# FCON rev.2 to rev.2 changes

## Schematic

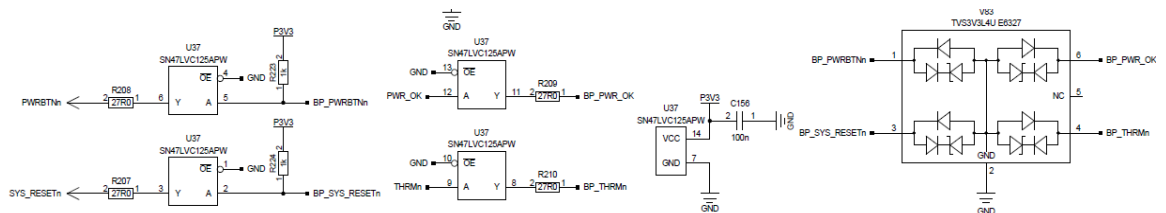
1. CPLD replaced by FPGA XC7S25-2FTGB196I
2. Added FPGA-flash MT25QL128ABA1EW9-0SIT + circuitry
3. Added DC/DC 3.3V to 1V, SC189ZSKTRT (FPGA core voltage)
4. CLKREQn circuitry, J25, R154 removed
5. Tricolor frontplate LED ASMB-MTB1-0B3A2 + high-pipe 515-1255-0590-F added
6. Backplane connector J20, pins B77..88 reassigned to BP\_FANx\_SENSE, 4x SBC signal removed
7. The following LEDs + control removed
